December 9, 2016

Subject: Response to Comments
Sediment Investigation Results and Proposed Additional Sediment Sampling
Sims Group USA Corporation, Redwood City, California

CLIENT: Sims Metal Management	**Proposed Additional Surface and Coring Sediment Locations - Wharf 3**
PROJECT: Sediment Investigation Report	
PROJECT NUMBER: 0012.001.007	**FIGURE 17**

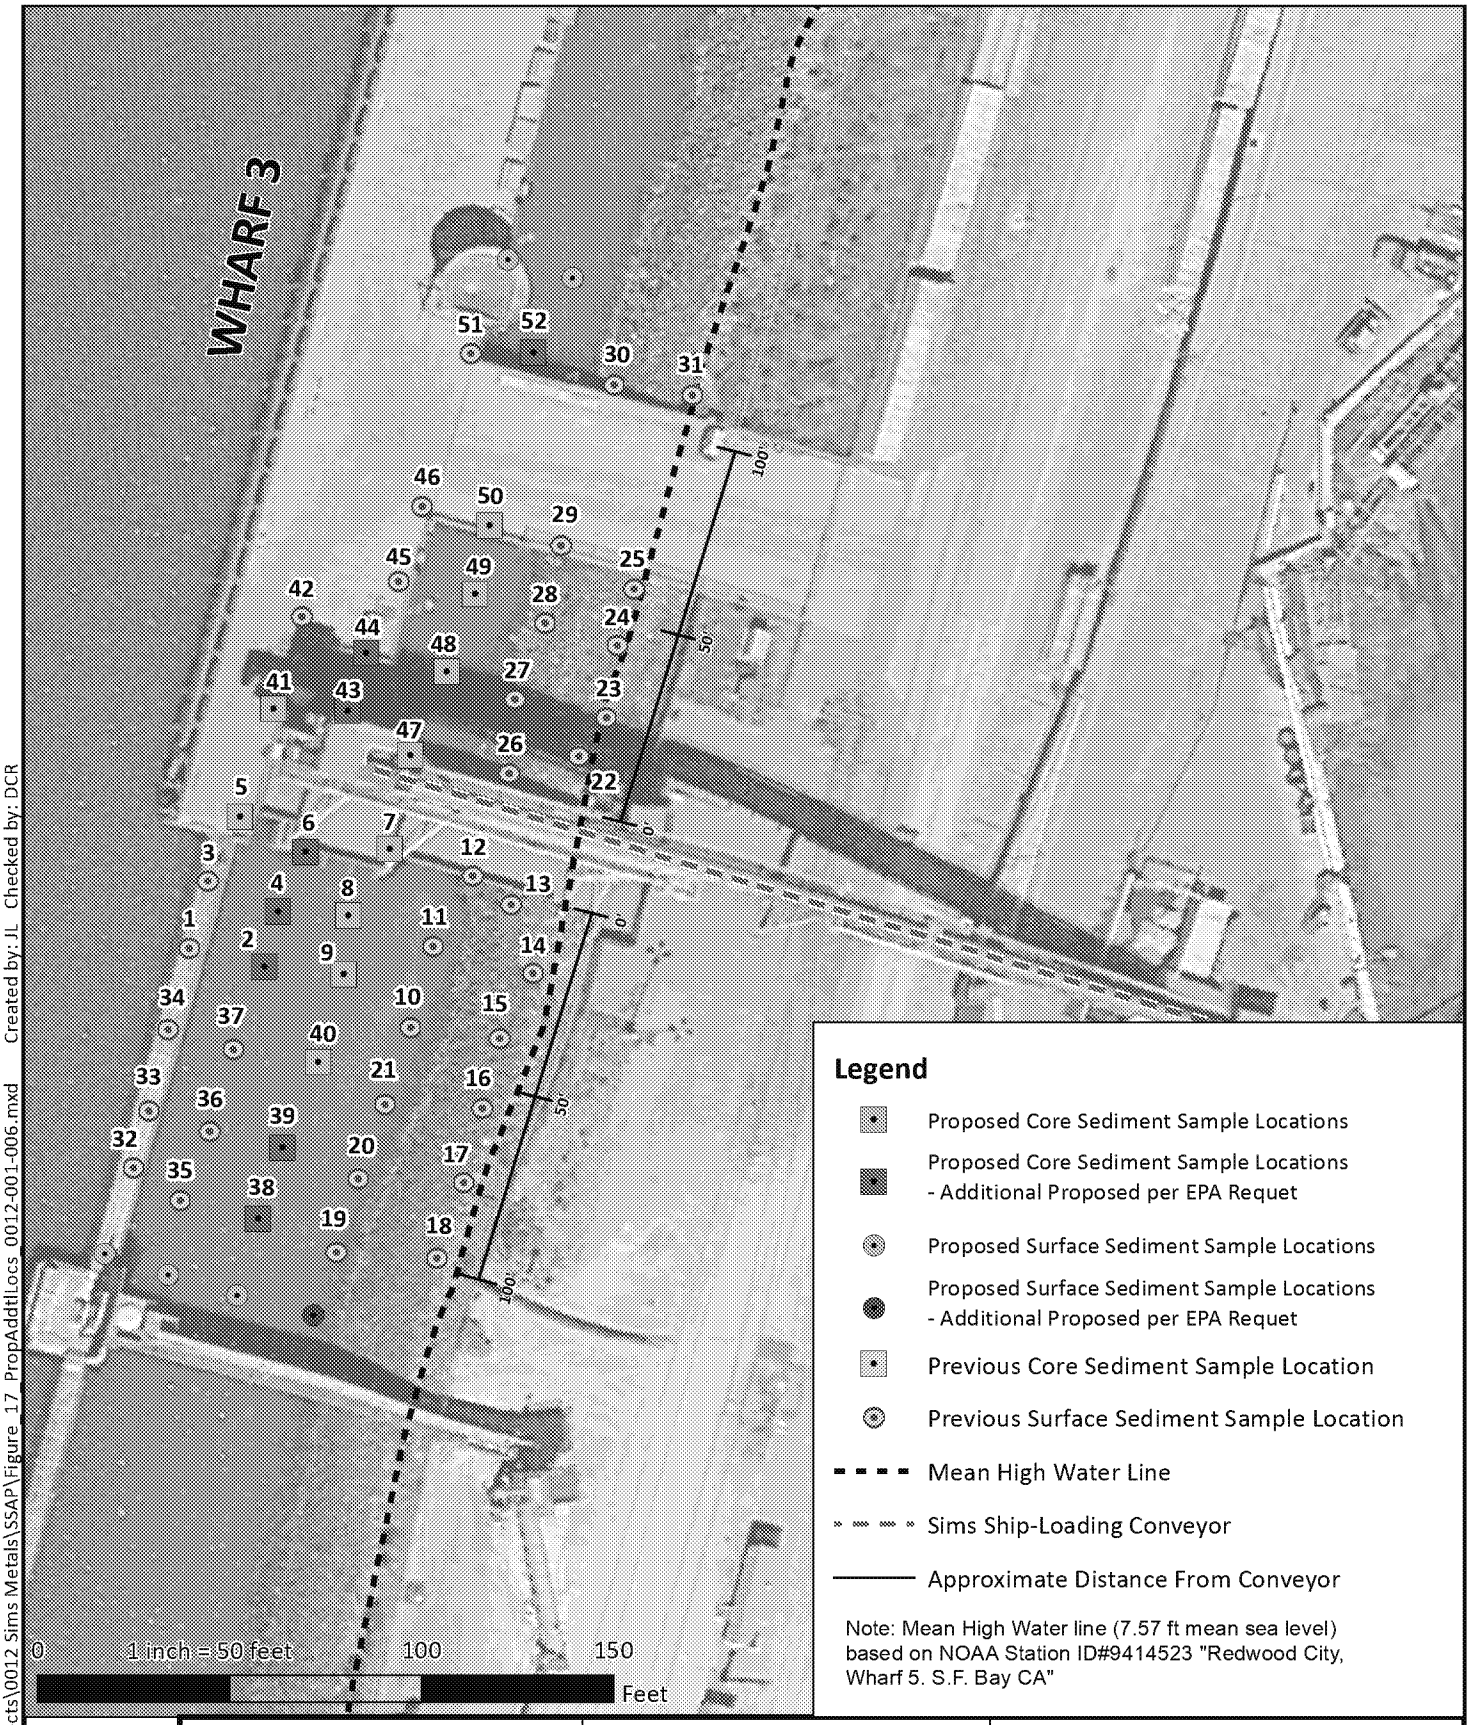
<u>EPA Comment</u>
PROJECT AREA SAMPLING
Add 8 Core Locations for lateral distribution*: The transect core locations proposed by Sims to the south of Wharf 3 (locations 7, 8, 9, 40) should also include core samples at locations 39 and 38. In addition, the transect core locations proposed by Sims to the north of Wharf 3 (locations 47, 48, 49, 50) should also include location 52. Lastly, in addition to the core samples for locations 5 and 41 proposed by Sims, EPA believes core samples should also be taken at locations 6, 4, 2, 43 and 44.*

EPA Comment
Surface Samples*: Sims has proposed taking 5 more surface samples within the project area (3 locations approximately 25 feet south of locations 32, 35, and 38, and 2 locations north of locations 51 and 52). We agree with those 5 locations, but believe that Sims should also take at least one other surface sample south of location 19.*

Response
The additional core sampling locations requested by the EPA will be added to the scope of work. A total of 18 sediment cores will be collected. The core sample identification numbers are summarized in Table 1. Figure 17 has been revised to indicate planned core sediment sample locations.

Response
Figure 17 has been revised to indicate that a surface sediment sample will be collected at location 19 in addition to the previously proposed locations. A total of six surface ponar grab samples will be collected.

CLIENT: Sims Metal Management	**Proposed Additional Background Riprap Sediment Sample Locations - Wharf 2**
PROJECT: Sediment Investigation Report	
PROJECT NUMBER: 0012.001.007	**FIGURE 18a**

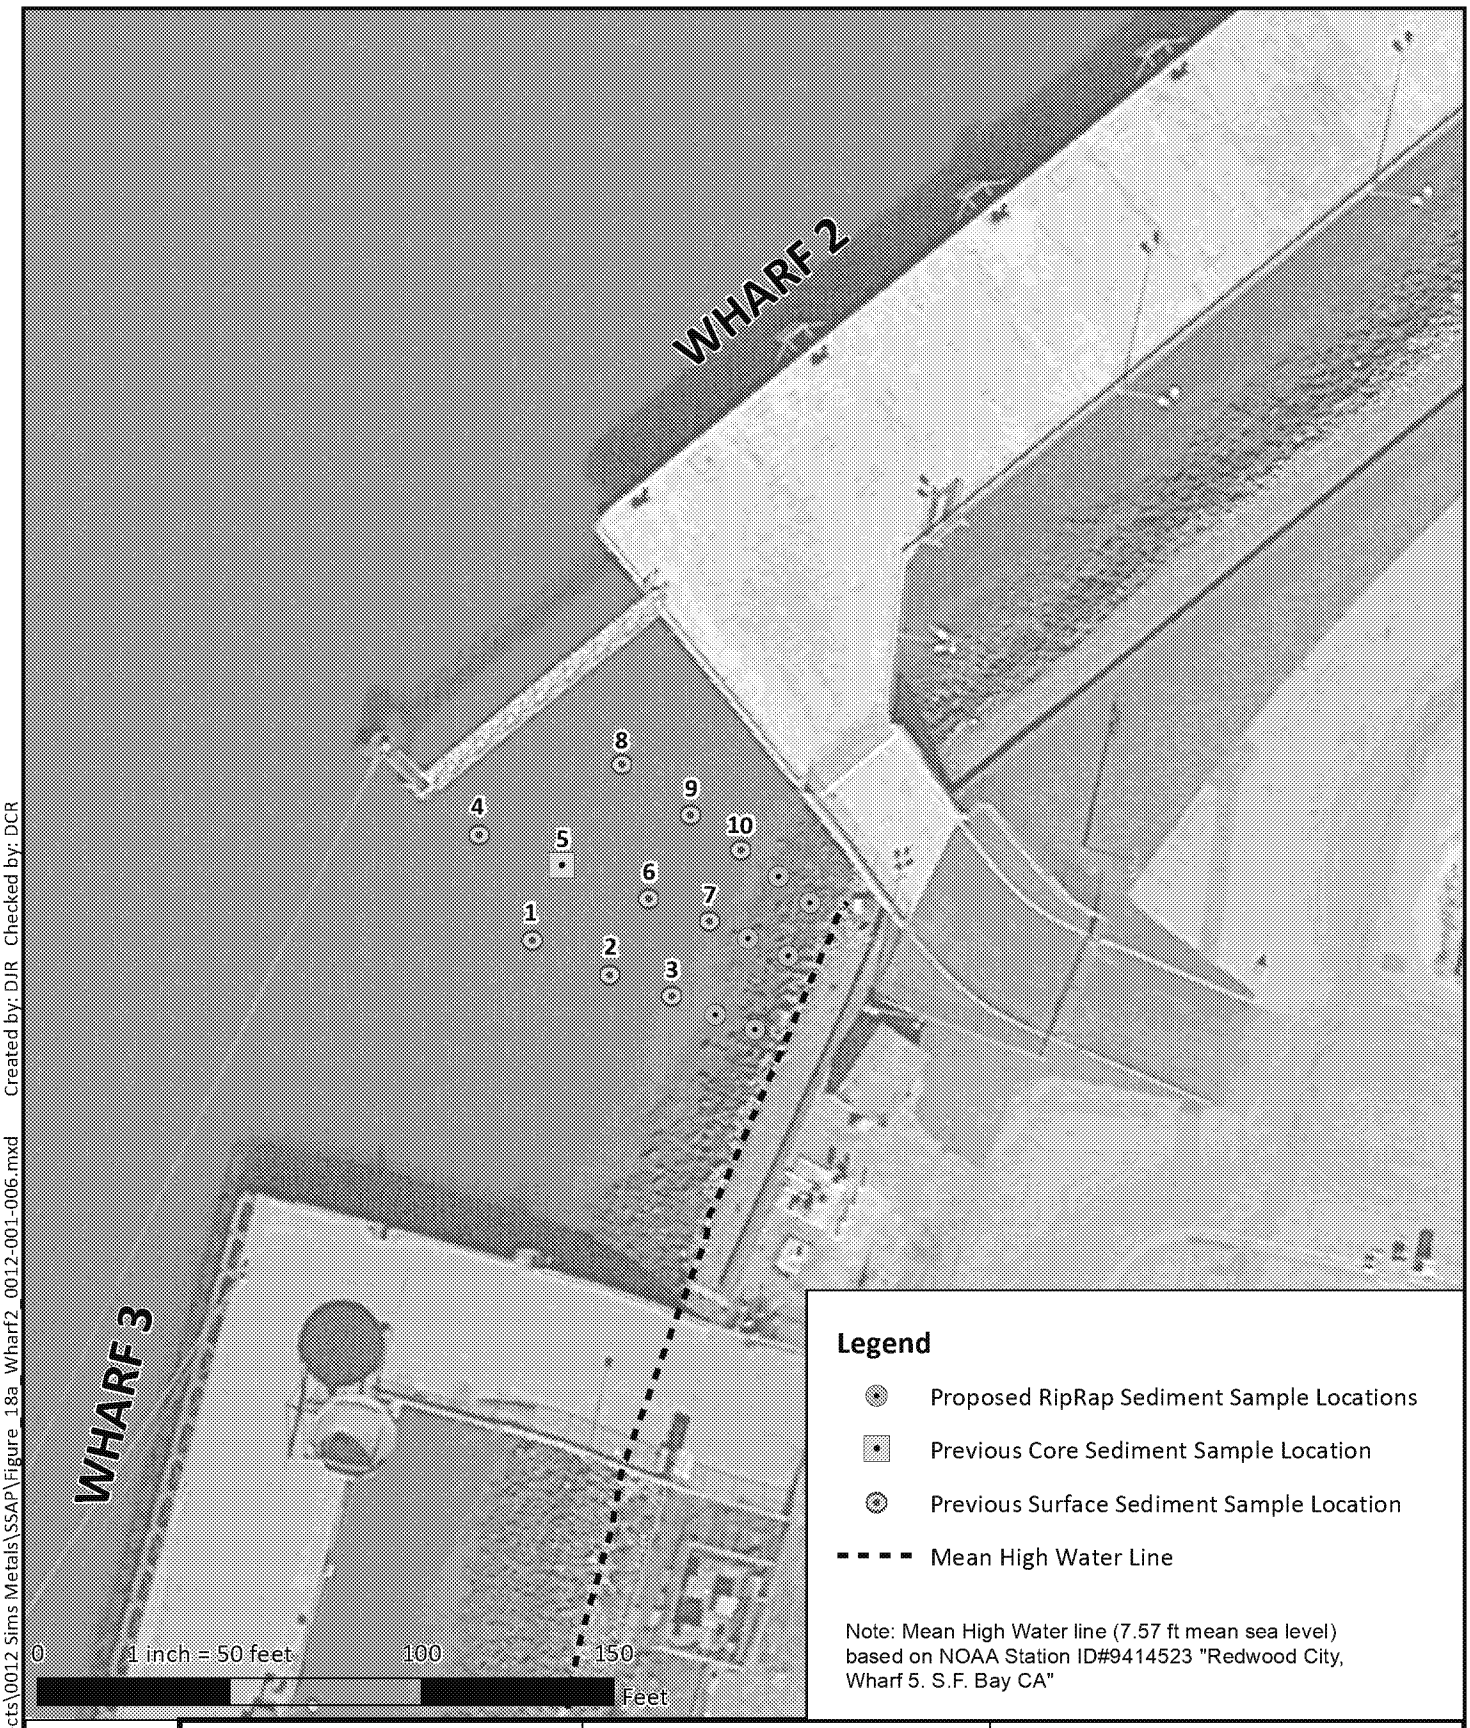
EPA Comment
BACKGROUND AREA SAMPLING
Surface Samples*: Sims has proposed taking 6 additional surface samples at each of the 3 background areas (Figures 18a, b, and c). In general, we agree with taking those samples, but for comparison, we believe they should be at elevations that are in line with the riprap surface sediments that were taken in the project area. Based on the aerial photos provided in its report, the locations Sims has proposed in the background areas seem closer to the mean high water line than the surface riprap samples within the project area. Please add a mean high water line to Figures 18a, 18b, and 18c and evaluate if the background sample locations need to be adjusted to match the elevation of similar grab samples in the project area.*

Response
The surveyed MHW line has been added to all figures that depict the background sample locations from the prior phase of investigation, and the proposed additional locations (Figures 18a, 18b and 18c). The proposed background locations are all below the MHW line.
